# SERVICE BULLETIN No. 292 72 2222

**Subject:**  
Module M02 (Compressor) - Replacement of the equipped jet.  
Modification TU 222.

Modification TU 222:

Equipped casing assembly  
**Figure 1**

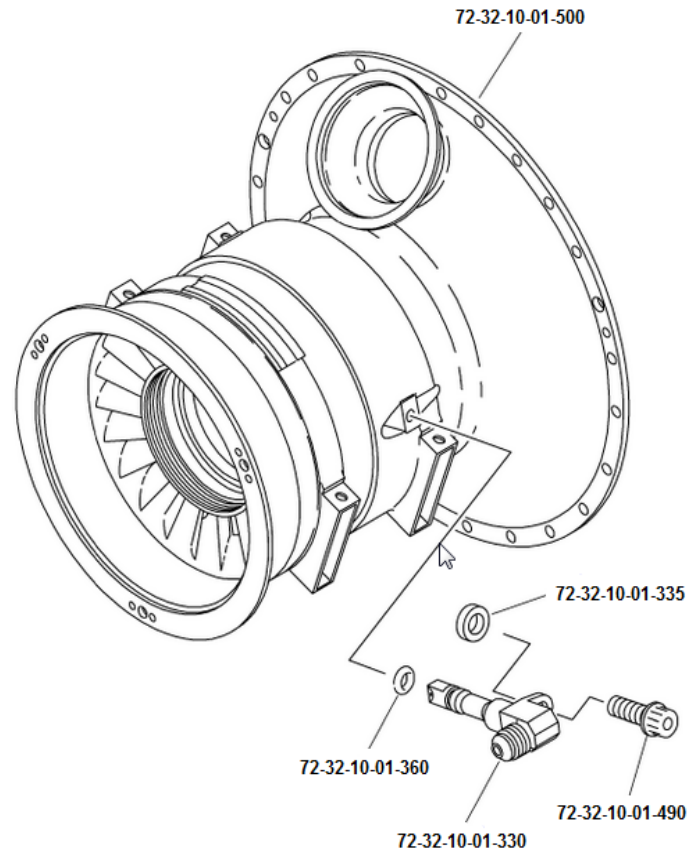
**2.6.2.2. Removal of the PRE TU 222 equipped jet (72-32-10-01-330) of the compressor casing (72-32-10-01-500)**

- 2.6.2.2.1. Remove the screw (72-32-10-01-490) that attaches the equipped jet.
- 2.6.2.2.2. Remove and discard the equipped jet (72-32-10-01-330).
- 2.6.2.2.3. Remove and discard the adjusting washer (72-32-10-01-340).
- 2.6.2.2.4. Remove and discard the preformed packing (72-32-10-01-360) from the equipped jet.

**2.6.2.3. Installation of the POST TU 222 equipped jet (72-32-10-01-330)**

- 2.6.2.3.1. Lubricate a new preformed packing (72-32-10-01-360).
- 2.6.2.3.2. Install a new preformed packing (72-32-10-01-360) on the equipped jet (72-32-10-01-330).
- 2.6.2.3.3. Put the equipped jet (72-32-10-01-330) in position in its housing in the casing (72-32-10-01-500).
- 2.6.2.3.4. Put the washer between the casing (72-32-10-01-500) and the equipped jet (72-32-10-01-330).
- 2.6.2.3.5. Install the screw (72-32-10-01-490) through the equipped jet (72-32-10-01-330) and the washer (72-32-10-01-335).
- 2.6.2.3.6. Tighten the screw (72-32-10-01-490) that attaches the equipped jet (72-32-10-01-330) to the apparent torque of 4.8 N.m.

**Figure 1**

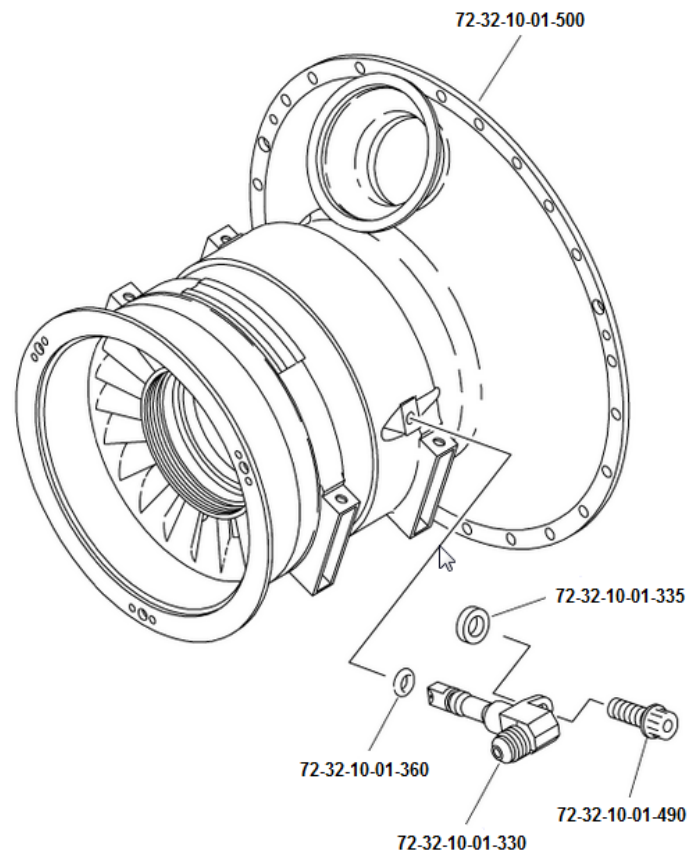
**4.6.2.2. Installation of the POST TU 222 equipped jet**

4.6.2.2.1. Lubricate a new preformed packing (72-32-10-01-360).

4.6.2.2.2. Install a preformed packing (72-32-10-01-360) on the equipped jet (72-32-10-01-330).

4.6.2.2.3. Install the equipped jet (72-32-10-01-330) on the compressor casing (72-32-10-01-500).

4.6.2.2.4. Put the washer (72-32-10-01-335) in position between the compressor casing (72-32-10-01-500) and the equipped jet (72-32-10-01-330).

4.6.2.2.5. Tighten the screw (72-32-10-01-490) to the standard torque: Refer to the Common Techniques Book, task 70-50-20-350-801.
